RE: 2005 Mitsubishi Lancer Evolution Turbo Charger Coolant Hose

# COOLANT HOSE REPLACEMENT — SAFETY RECALL CAMPAIGN

No: SR-05-004

MODEL: 2005 Lancer Evolution

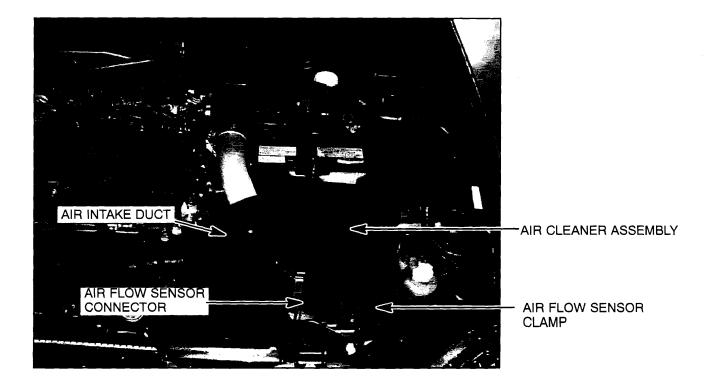
The turbocharger water feed hose on affected vehicles was incorrectly manufactured, and as a result may allow coolant leakage. Since the hose is located near the exhaust manifold, if a leak occurs during vehicle operation when the manifold is hot, coolant may ignite and cause a vehicle fire. Dealers must replace the turbocharger water feed hose as described in this bulletin.

- 1. Place a metal or plastic receptacle under the vehicle, directly under the water hose area, to collect any spilled coolant.
- 2. Carefully remove the radiator cap to release system pressure. Then reinstall the cap.
- 3. Remove the air intake duct and the air cleaner assembly.
- 4. Remove the air flow sensor connector and its clamp.

- 5. Remove the intercooler hose.
- 6. Remove the air intake hose.

7. Replace the turbocharger water feed hose.

8. Reinstall the intercooler hose, air intake hose, air flow connector and clamp, air cleaner assembly, and air intake duct.

- 9. With the radiator cap removed, bleed air from the system by starting the engine and idling until the thermostat is opened (approximately 20 minutes).
- 10. Replenish coolant as needed in the radiator and coolant reservoir. Reinstall the radiator cap.
- 11. Use plain water to clean up any spilled coolant.

- 12. Apply a small white paint dot to the rocker cover bolt as shown.
- 13. Confirm that all hoses, clamps, clips, connections, and bolts are secure.
- 14. Confirm there are no coolant leaks.
- 15. Confirm the coolant level is correct.
- Start the engine and confirm there is no abnormal noise.
